*Re: Beacon 248 Holdings LLC – Proposed Multifamily Development and Office Building
(Formerly Beacon 248 Development, LLC, Multifamily Development)
248 Tioronda Avenue, City of Beacon, Dutchess County, NY
Chazen Project #81750.00*

*Re: Response to John Clarke Planning and Design Comments dated February 8, 2019, and
Lanc & Tully Comments dated February 7, 2019
248 Beacon Holdings LLC - Fishkill Creek Development Concept Plan for 248 Tioronda Avenue
(Formerly Beacon 248 Development, LLC, Multifamily Development)
248 Tioronda Avenue, City of Beacon, Dutchess County, NY
Chazen Project #81750.00*

*Re: Response to John Clarke Comments dated 03/07/2019, Lanc & Tully Comments dated 03/08/2019, NYSDOT comments dated 03/21/2019, and Public Comments at 03/12/2019 Public Hearing
248 Beacon Holdings LLC - Fishkill Creek Development Concept Plan for 248 Tioronda Avenue
(Formerly Beacon 248 Development, LLC, Multifamily Development)
248 Tioronda Avenue, City of Beacon, Dutchess County, NY
Chazen Project #81750.00*

*Re: Response to John Clarke Comments dated 04/04/2019, Lanc & Tully Comments dated 04/01/2019,
Creighton Manning Comments dated 04/29/2019, and Additional Public Comments
248 Beacon

Figure 2
Access Drive from Previously Approved Plan

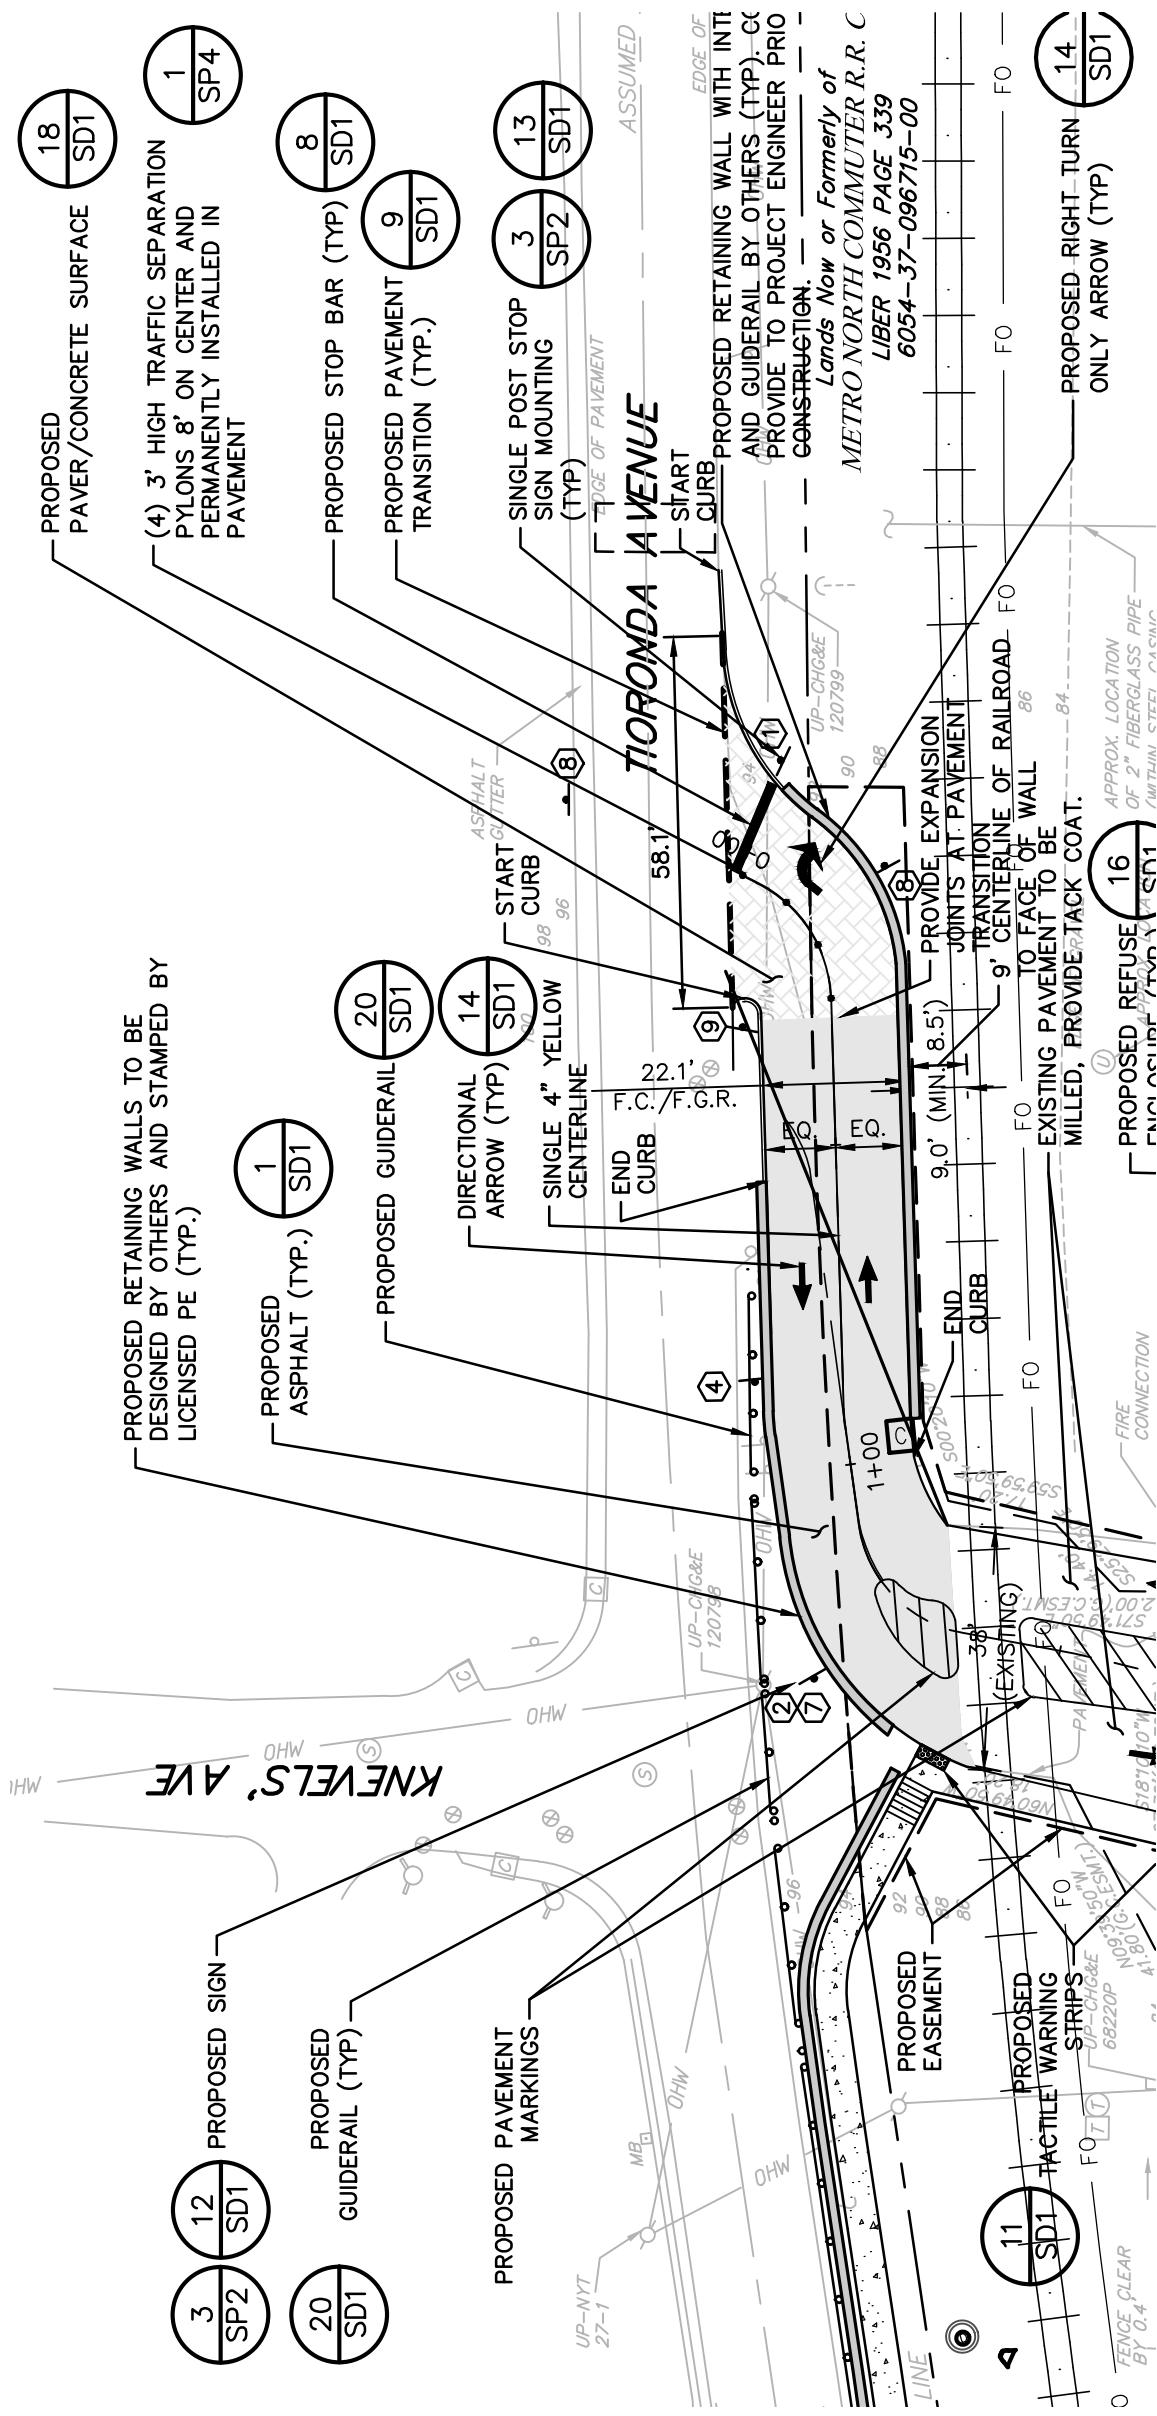
6. *Noted Knevels Ave steep grade going down into Tioronda Ave.*

Response: As part of the previous site plan approval, a guide rail is proposed on the east side of Tioronda Ave directly across from Knevels Ave. Please refer to Figure 2 attached.

PROJECT EXIT SIGHT DISTANCE: TIORONDA AVENUE TO LEFT

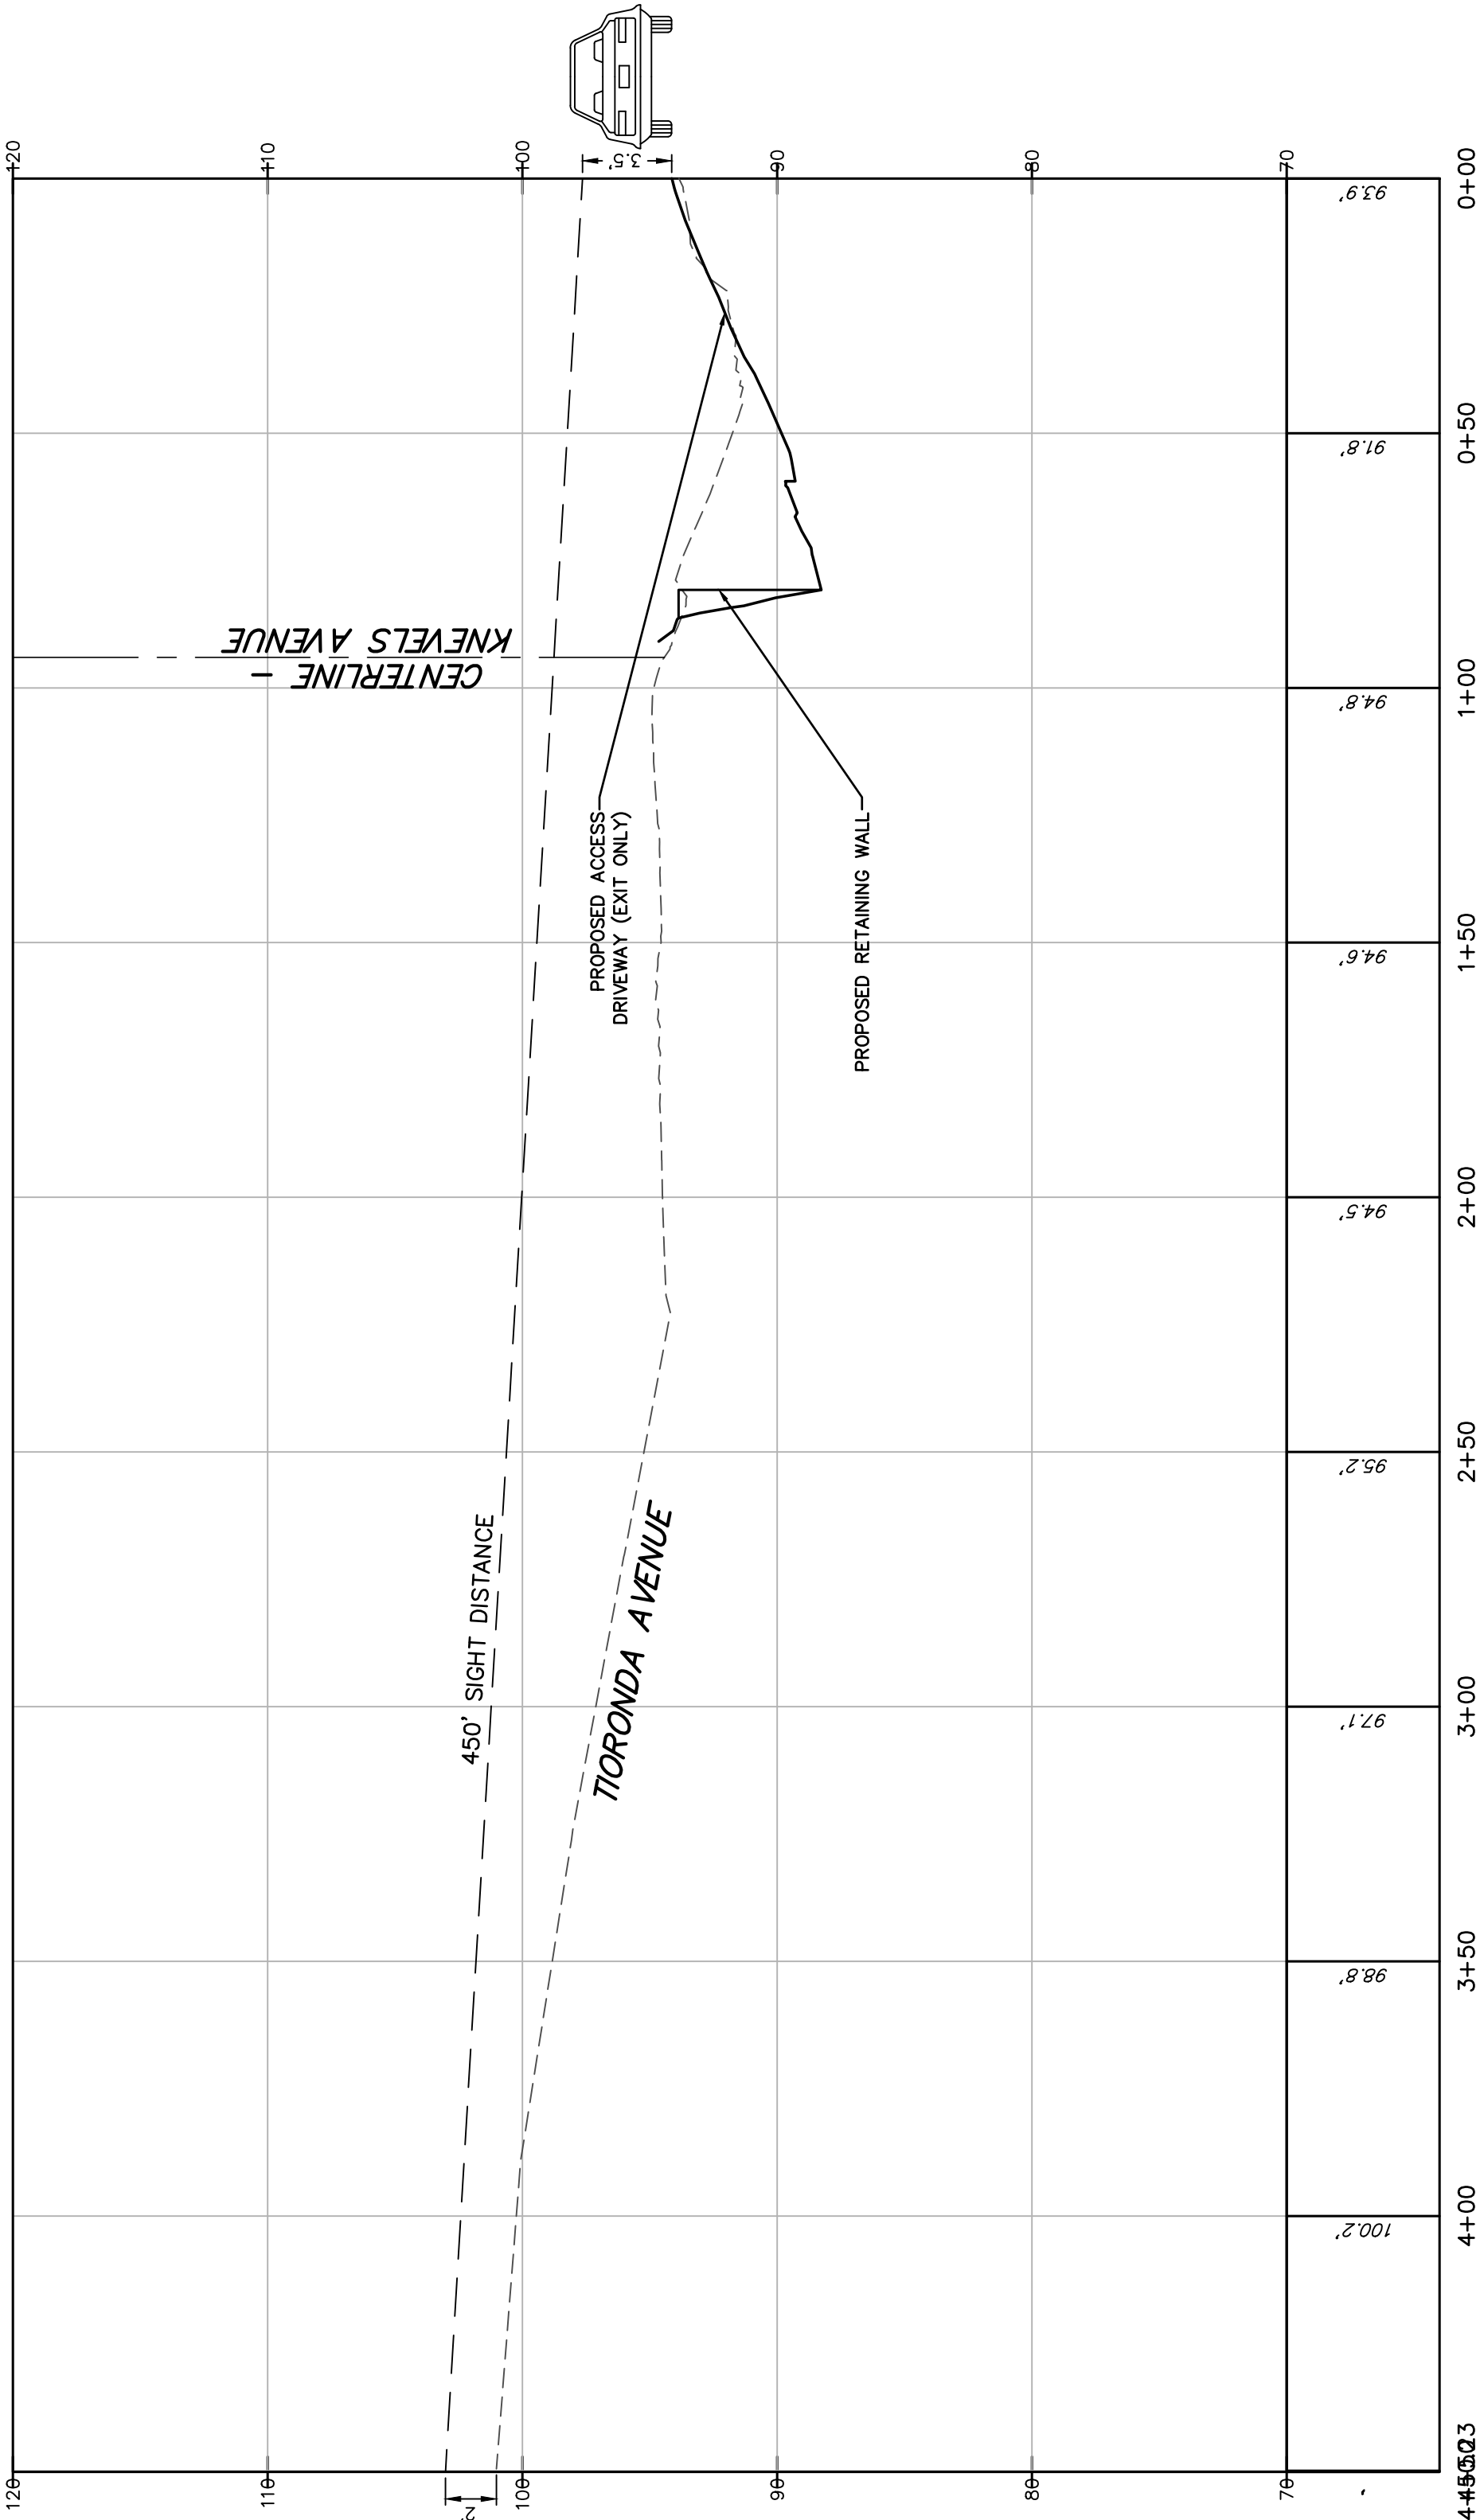
5. *Exiting the project site, review site line.*

Response: The site line looking south down Tioronda, while exiting the site, has been reviewed under the previously site plan approval and found to be acceptable with the vegetation removed.
